CLEARFIELD CITY PLANNING COMMISSION MEETING AGENDA

SUBJECT: Discussion and Possible Action on **FSP 2021-020028**, a final subdivision plat request by Spencer Barber for a 14-lot single-family subdivision at the subject location. **Location:** 245 North 1000 West (TIN's: 12-024-0017 & 12-024-0018). **Total Parcel Area:** 3.16 acres. **Zone:** R-1-6 (Residential). **Planner:** Brad McIlrath (Administrative Action).

Attn: Brad McIlrath, Senior Planner
Proj: **Woods Court Subdivision**
Subj: Plat and Improvement Drawing Review #2

DEMOLITION PLAN

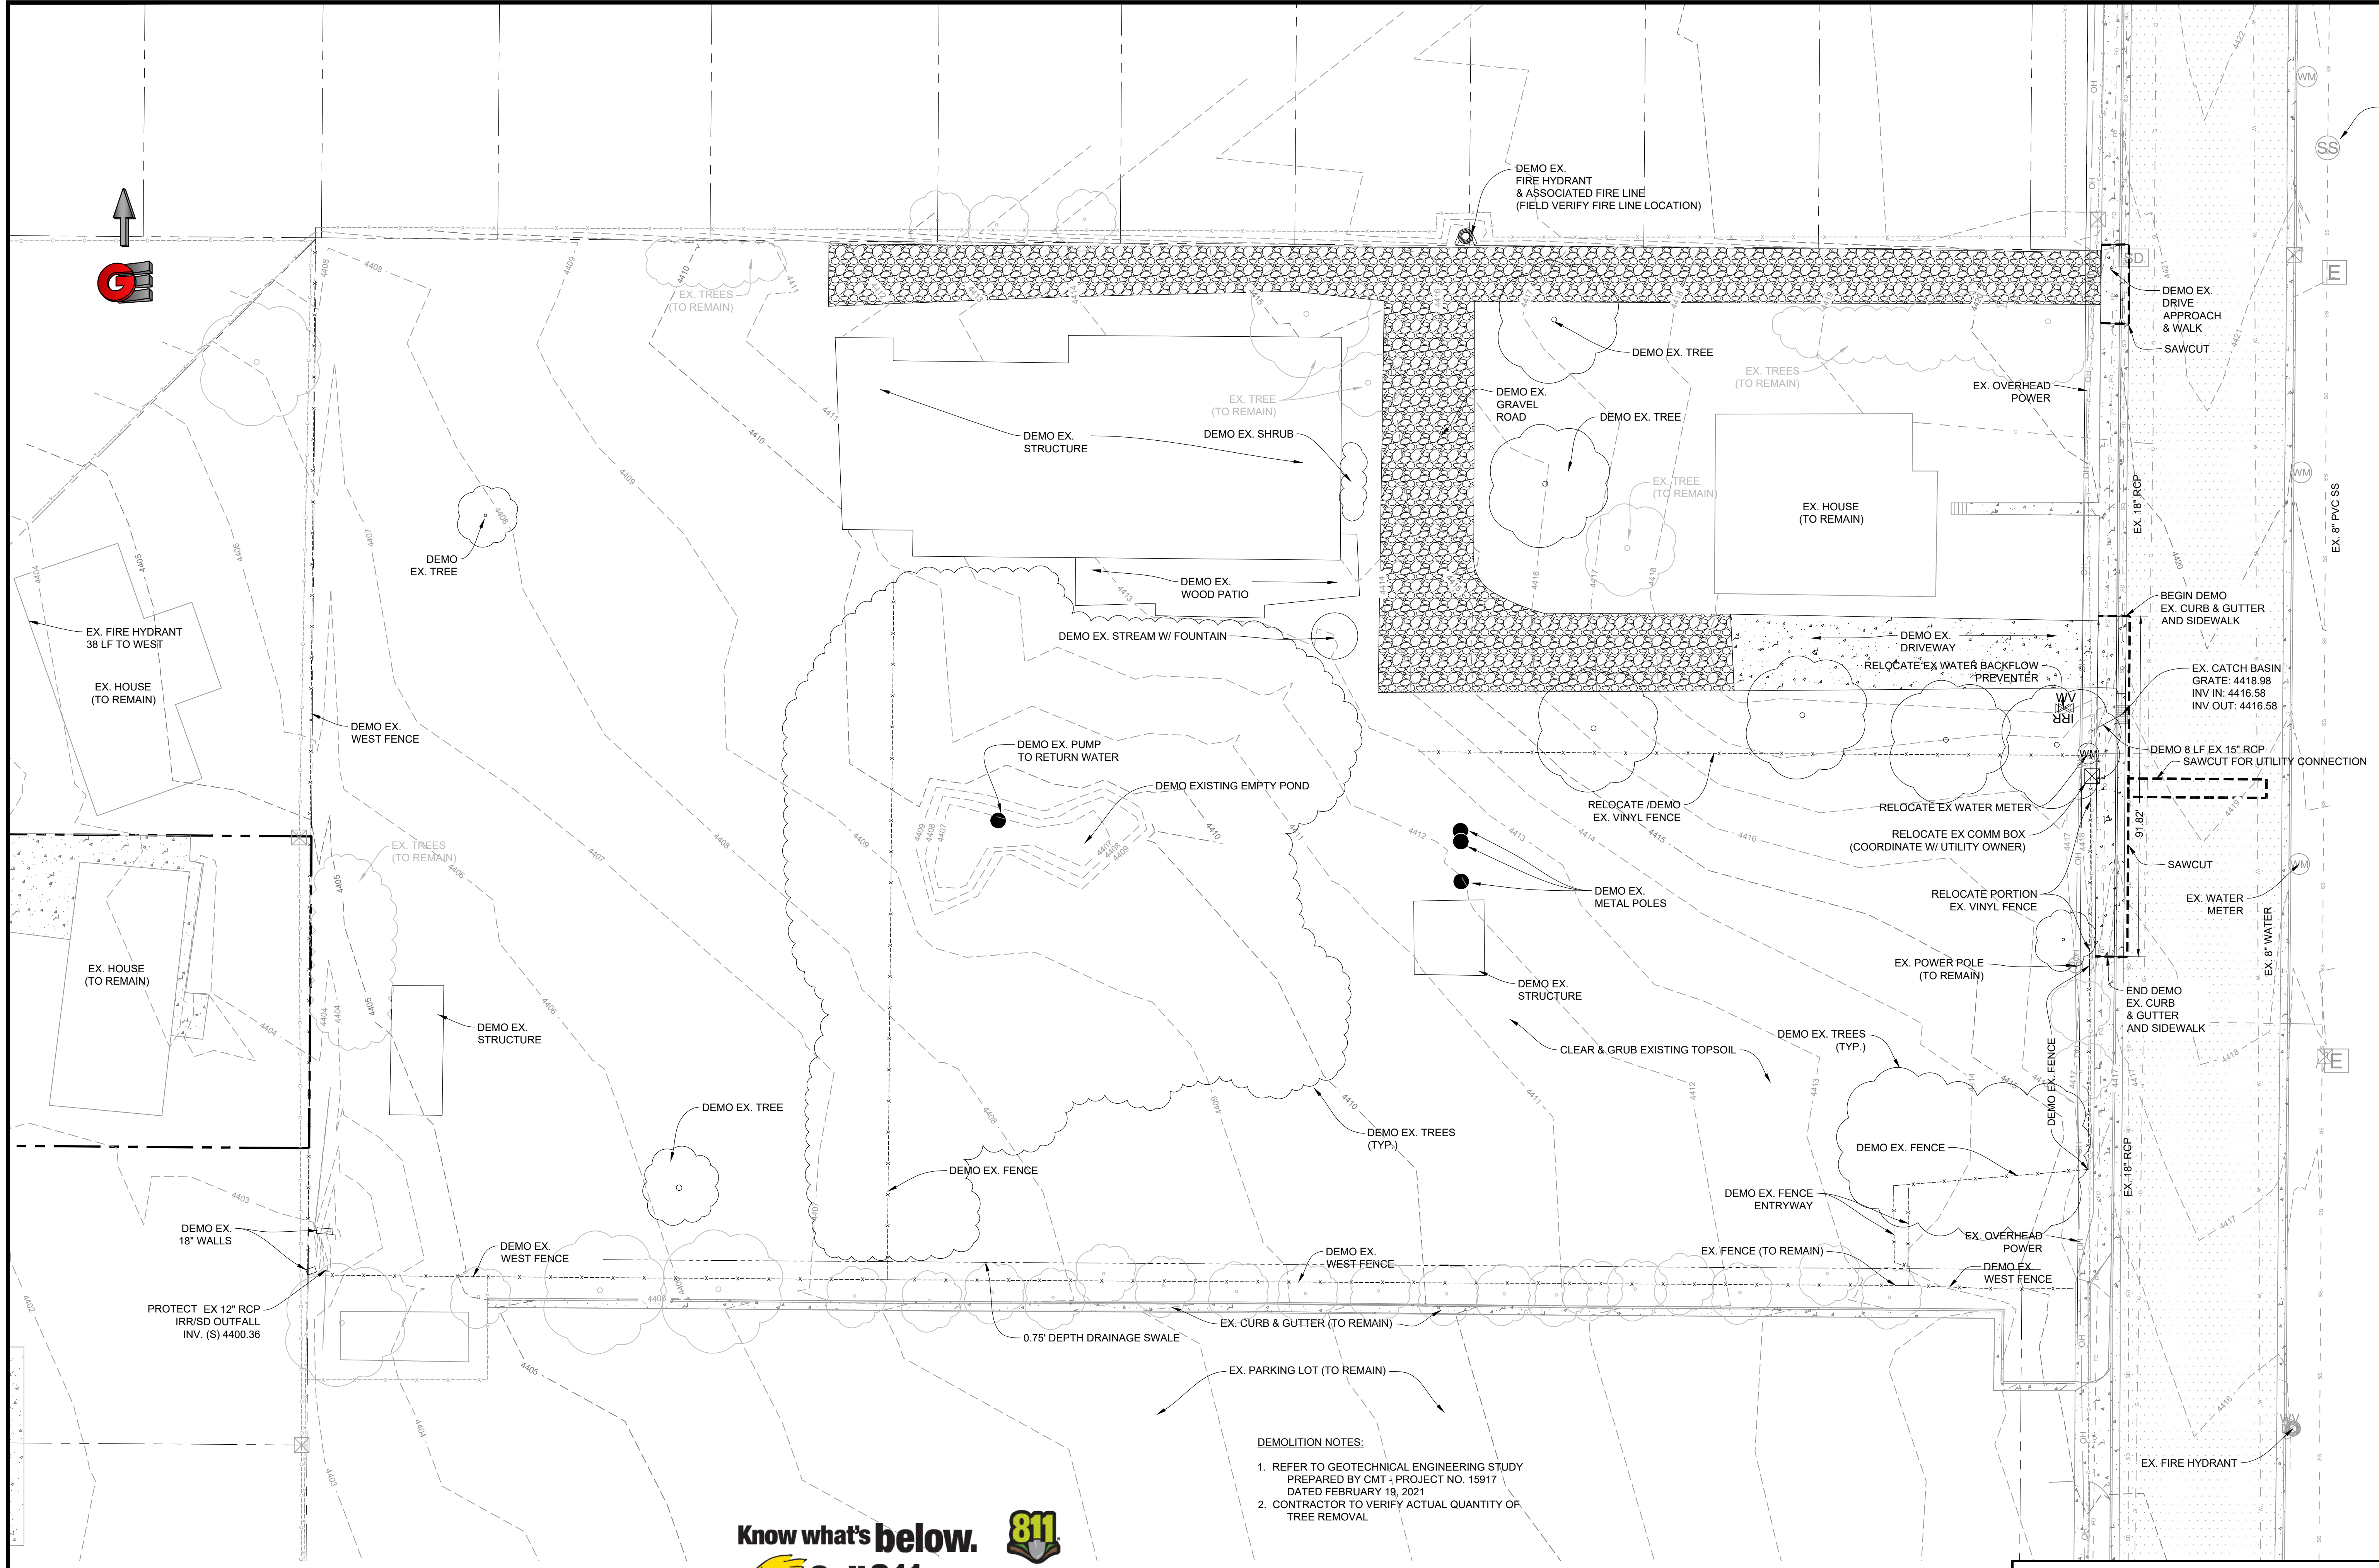
Demolition Plan – Sheet CE1-00

1. The following note is required to be added to the Demolition Plan sheet. Any and all existing service laterals, if being abandoned must be removed and capped at the City main line source, **add the appropriate notes.**

CE1-00

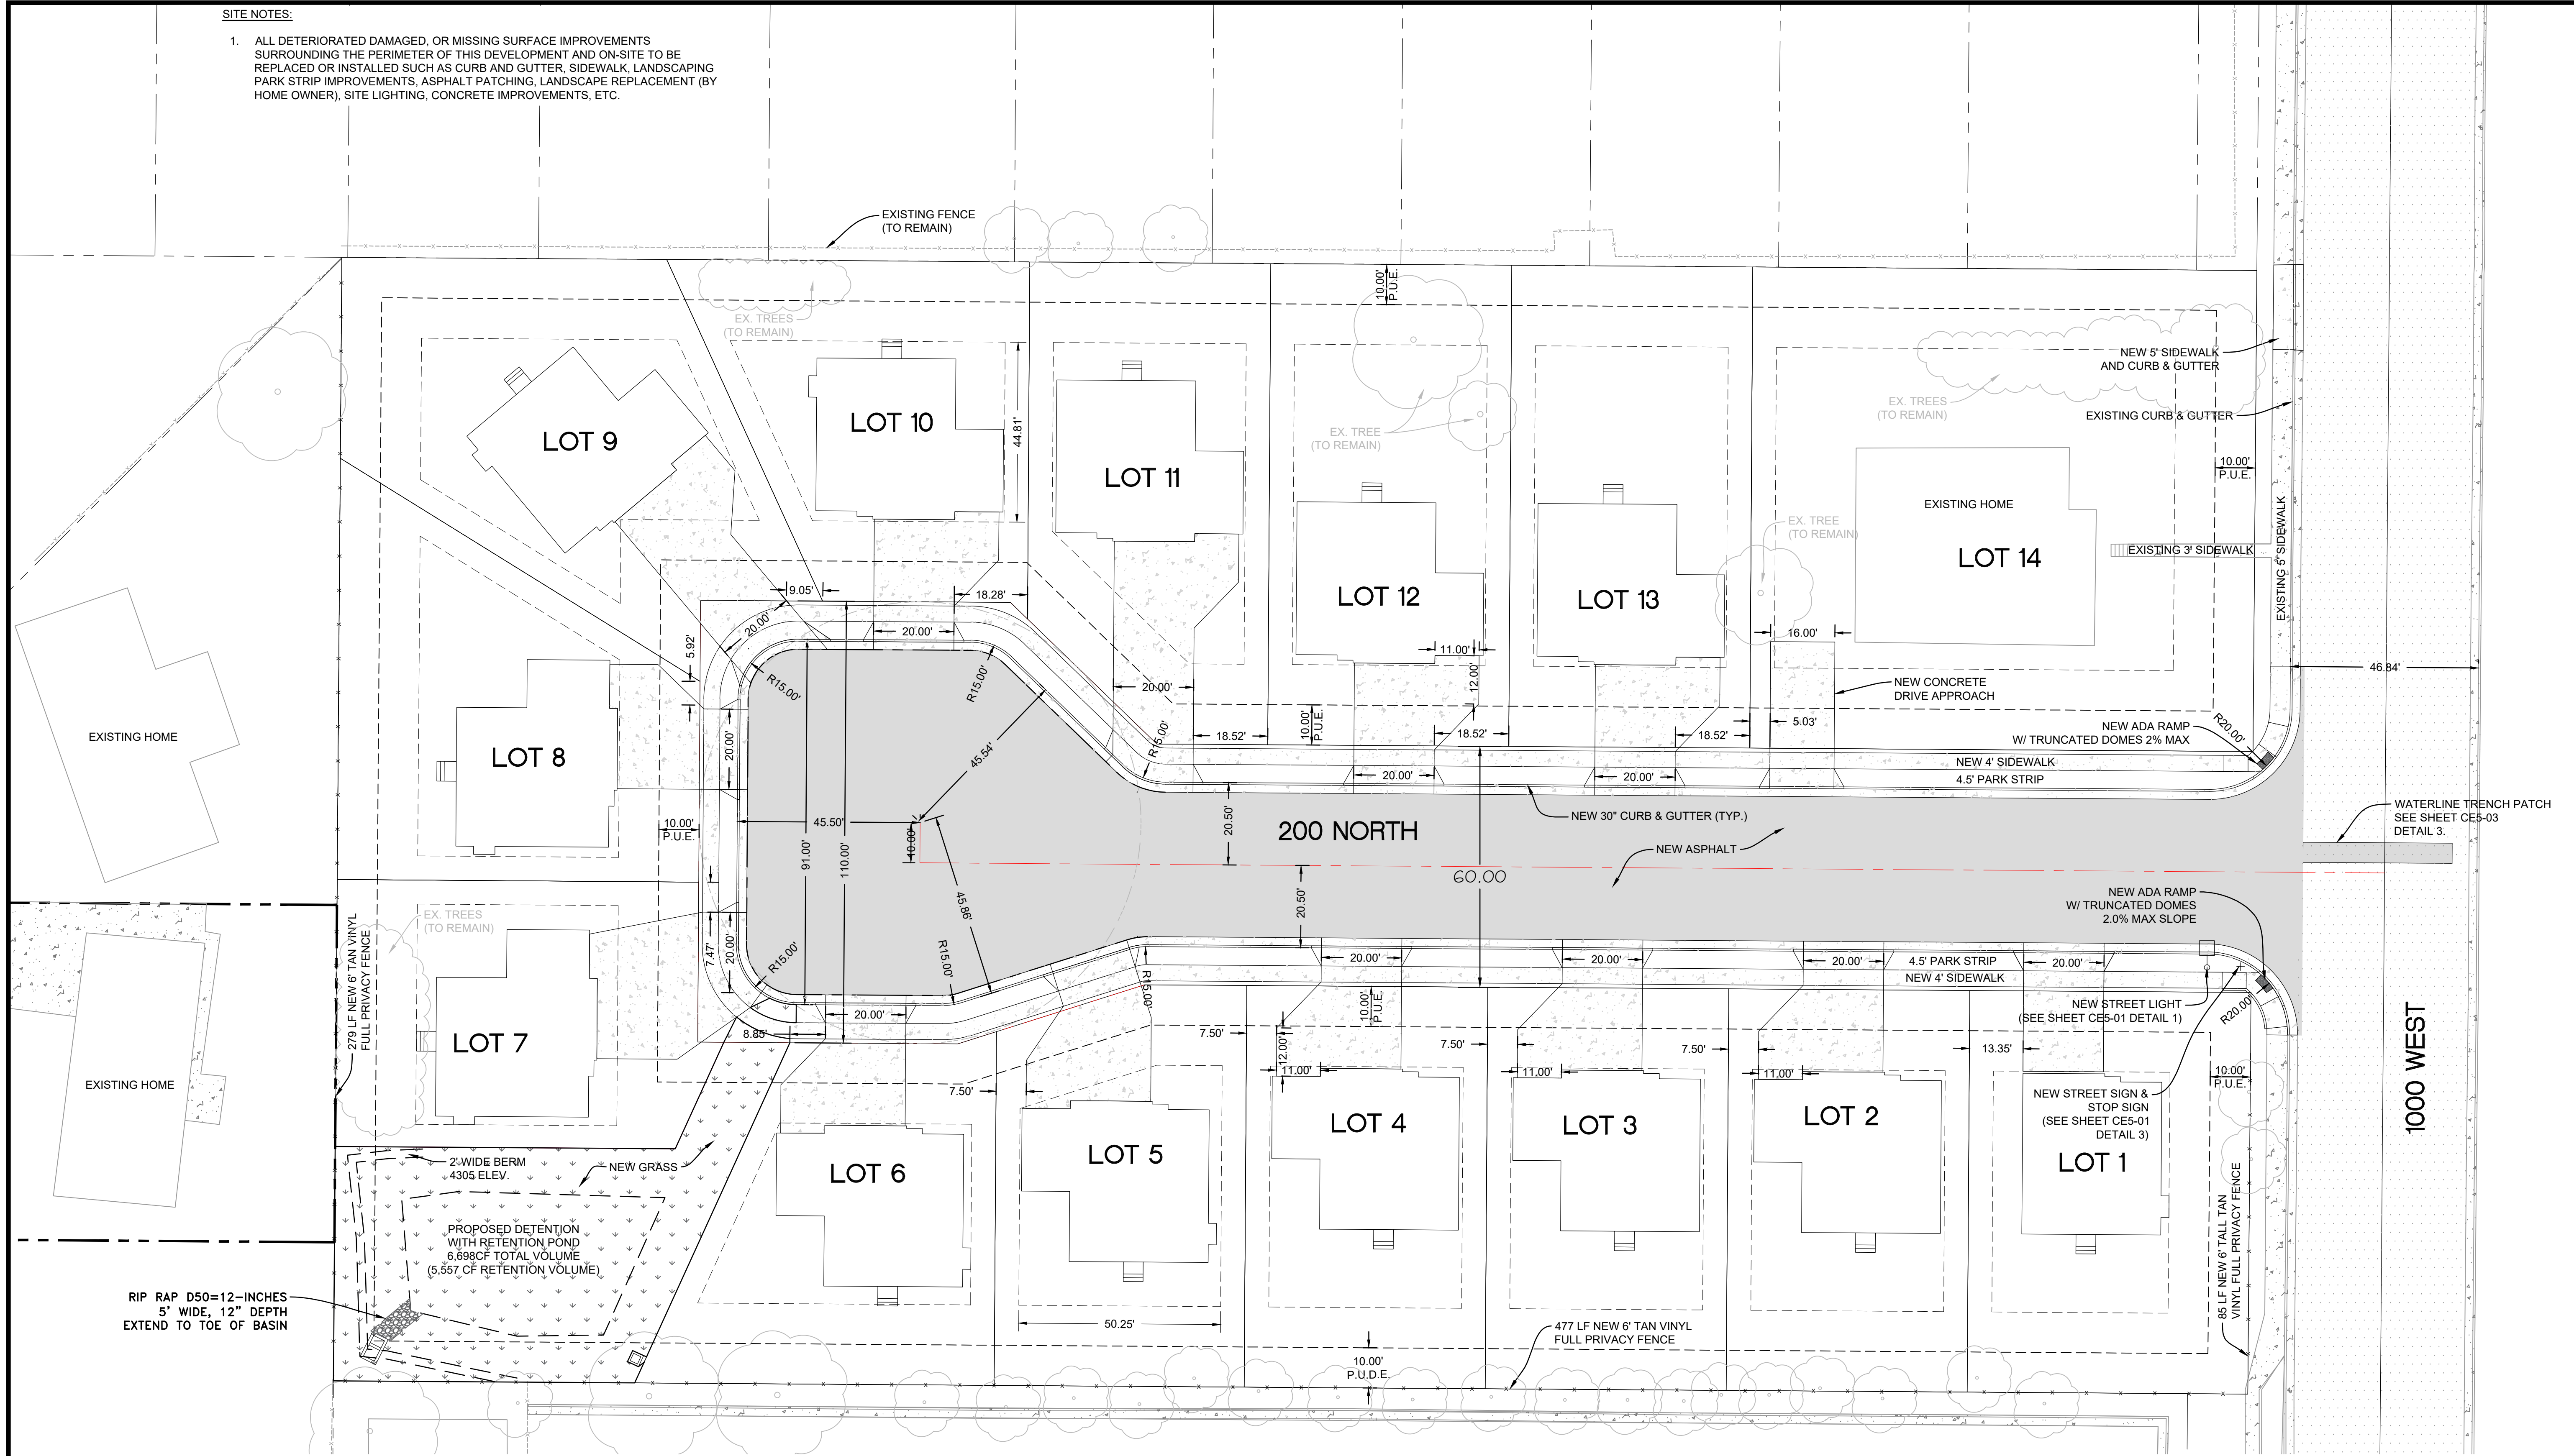
Site Plan – Sheet CE1-01

1. Add a note to the drawing stating how and by whom will the detention/retention storm water basin be landscaped and irrigated?
2. Add a note to the Pavement Shading on the "plan-view" of the drawing stating that 10" of untreated roadbase and 3" of bituminous asphalt paving is required for 200 North Street, per Clearfield City design standards noted below on sheet CE-01.
3. Add a note to the utility patching on 1000 West Street that the asphalt patch is to be a standard **"Tee" patch.**
